Product Limitation Note

EA-OEM-401

This errata note affects a specific production batch of the LPC3250 OEM board (product number: EA-OEM-401). The board is also sold as part of the LPC3250 Developer's Kit (product number: EA-OEM-410).

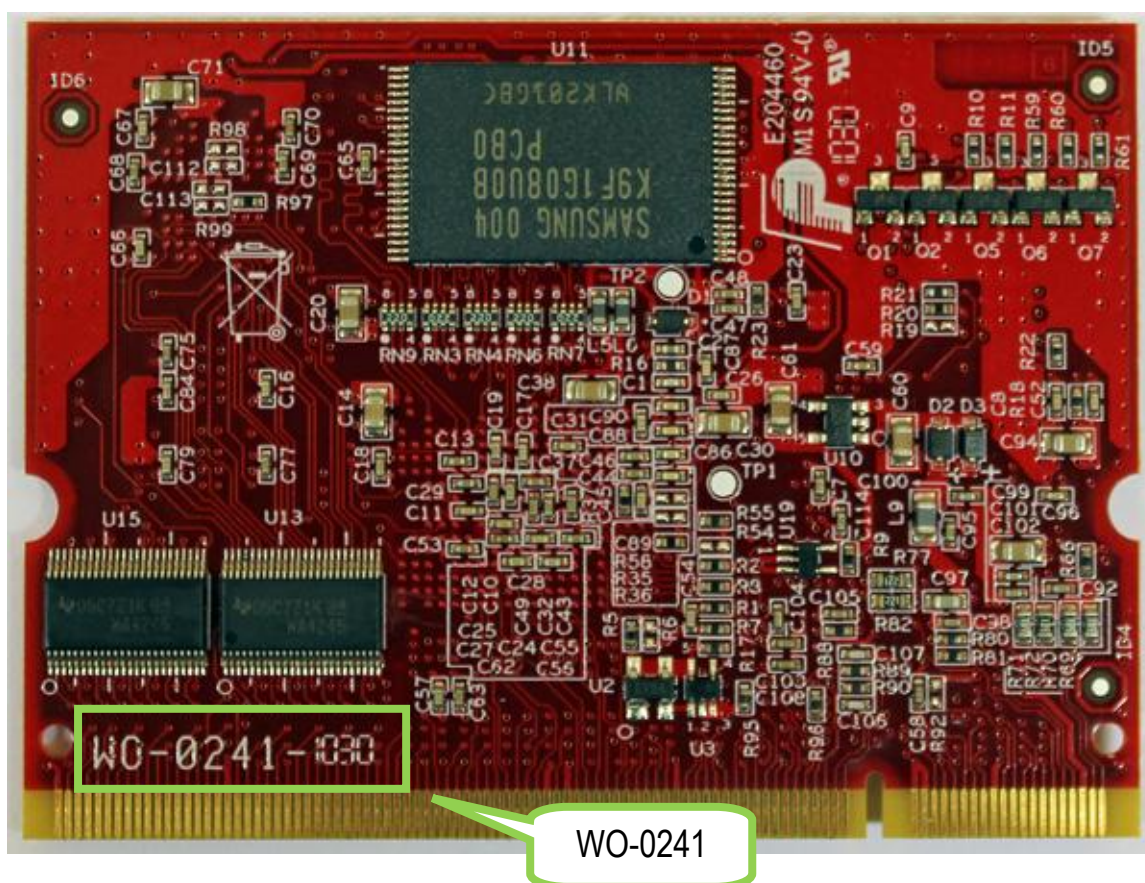
The affected production batch of the LPC3250 OEM board is identified on the backside of the board, see picture below.

Boards marked with “WO-0241” are affected.

Boards that do not have this exact marking are not affected.

The LPC3250 OEM board has previously used the Micron DDR SDRAM MT46H32M16LFCK-6. This chip has been obsolete by Micron. The chip that Micron recommend as a replacement, MT46H32M16LFBF-6:B, is used instead.

With the new DDR SDRAM, the design is affected by the DDR.2 errata of the LPC3250. See NXP LPC3250 errata documentation for details about this problem. In short, the problem is that the DQM0/DQM1 signals arrive a little too early compared to the 16 data bit signals. They need to be delayed (in the region of 200pS) to get reliable operation over the full temperature range (0-70 degrees Celsius).

The result is unreliable operation at 266 MHz core frequency. Most boards work at 266 MHz at room temperature and are fully functional. They may however fail with increasing temperature. Heavy usage pattern of the DDR SDRAM can make operation more unreliable. Tests show reliable operations at 215 MHz with 60 degrees Celsius temperature.

For most customers evaluating, and working with, the LPC3250 OEM board in room temperature and on the QVGA Base board, there is no problem. Most boards are fully functional under these conditions. In case of problem, set the core frequency to 208 MHz or 215 MHz. Tests show reliable operations at 215 MHz with 60 degrees Celsius temperature.

For customers integrating LPC3250 OEM boards in end-products, Embedded Artists recommend to clock the boards at 208 MHz or 215 MHz.

If 266 MHz operation is needed over full temperature range, please contact Embedded Artists for replacement.
